This is to certify that ROSA TRUE SCHOOL LIMITED PARTNERSHIP/Marcus Payne
has permission to Change of use from Utility room / storage to apartment for on site maintenance personnel
AT 140 PARK ST GBL 045 A006002

City of Portland, Maine - Building or Use Permit Application

**ROSA TRUE SCHOOL
 RENOVATIONS**

FIGURE-A = EXISTING

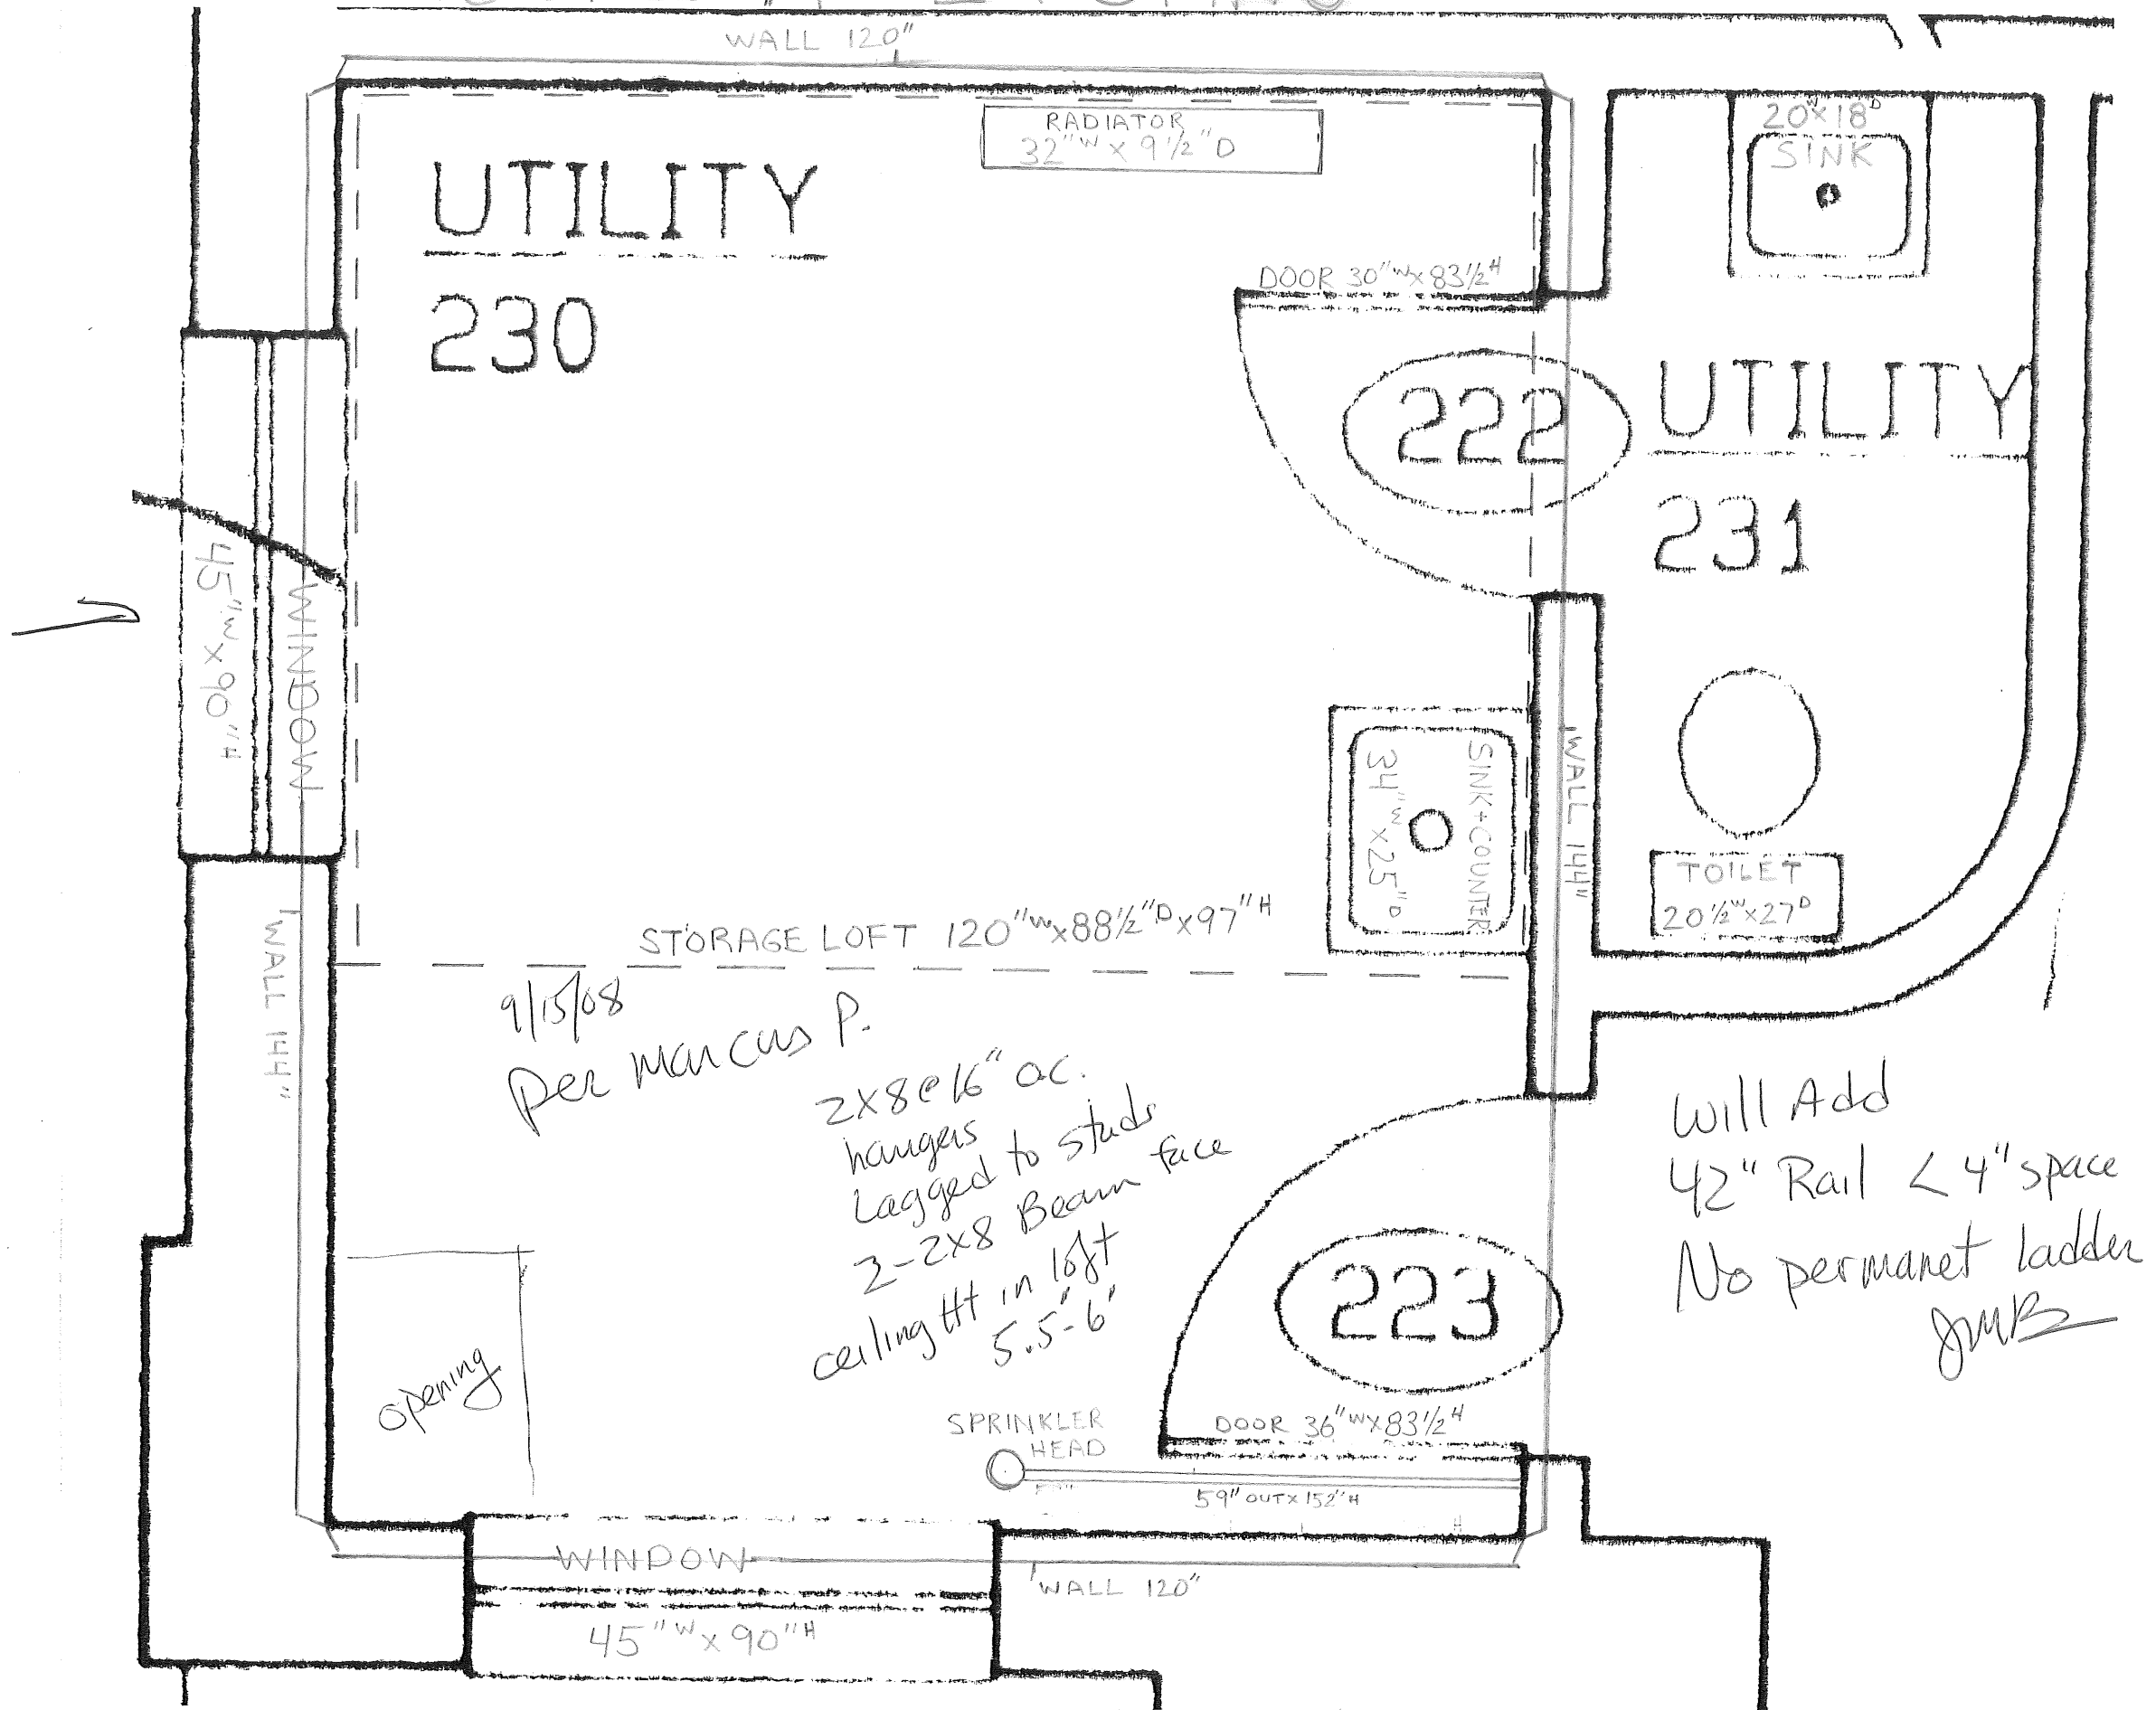
9/15/2008-jmb: Spoke to Marcus P. About the construction of the existing storage loft , see notes on figure A plans. Discussed guardrail, he will install per notes. He asked about distance between fixtures as it will be tight from the toilet to the shower. He will get the measurements.

9/19/2008-jmb: Marcus called and confirmed there will be 25" of clearance in front of the toilet to the shower stall. The height under the loft is 7'-5" and above the loft is 5'-5".

- 1) All penetrations through rated assemblies must be protected by an approved firestop system installed in accordance with ASTM 814 or UL 1479, per IBC 2003 Section 712.
- 2) Loft is existing, no permanent ladder allowed for access, for storage only, not for habitable space.
- 3) Permit approved based on the plans submitted and reviewed w/owner/contractor, with additional information as agreed on and as noted on plans.
- 4) Separate permits are required for any electrical, plumbing, or HVAC systems. Separate plans may need to be submitted for approval as a part of this process.
